**SUPPLEMENT TO THE DRAFT  
ENVIRONMENTAL IMPACT STATEMENT  
FOR A GEOLOGIC REPOSITORY FOR THE DISPOSAL  
OF SPENT NUCLEAR FUEL AND HIGH-LEVEL RADIOACTIVE WASTE  
AT YUCCA MOUNTAIN, NYE COUNTY, NEVADA  
(DOE/EIS-0250D-S)**

**FORMAL RESPONSE SUBMITTED BY  
CLARK COUNTY, NEVADA  
July 5, 2001**

Figure 2 Truck Transportation Routes Through Urban Clark County

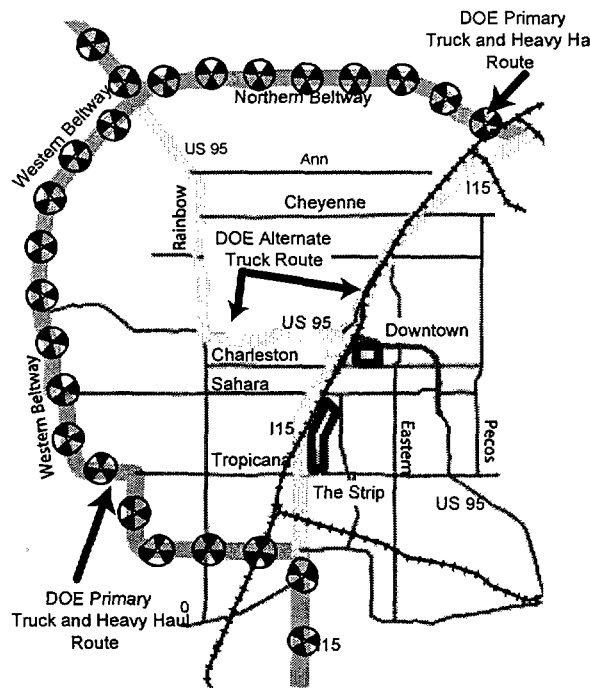
The DEIS assumed that DOE would be able to ship HLW using Clark County's planned northern and western beltways. However, these "beltways" are unlike beltways in other communities in several important respects. First, Clark County's beltway system is entirely paid for with local tax dollars and is not part of the Federal Highway System. As a result, Clark County's beltway is ineligible as a HLW route under Appendix A of HM 164. Another concern is that the beltway is being constructed as a frontage road rather than as a typical beltway facility. This is another reason Clark County's beltway system is ineligible as a transportation route. This means the primary route used for the truck transportation of HLW is likely to be Interstate 15 and US Highway 95 through Las Vegas. The SDEIS did not consider our comments in this area. However, the assumption that DOE cannot use the Clark County beltway system was used in this assessment.

Figure 5 Air Quality Impacts on Clark County

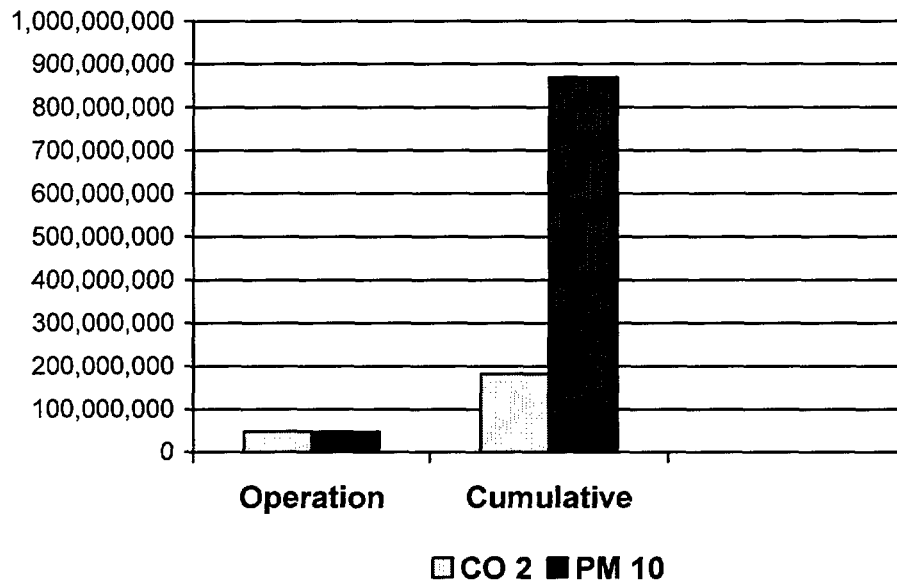
The upper boundary of the air quality impacts on the residents of Clark County due to air quality pollution caused by the NPA and the disposal of LLW at the NTS are:

The air quality impacts due to the YMP will substantially degrade Clark County’s air quality. They will make it increasingly difficult for local government to meet air quality goals and could cause other Federal agencies to take punitive action on Clark County due to the YMP. The NPA should have been prepared to accommodate the regional transportation plans and conform to the FHWA’s regulations for statewide planning.
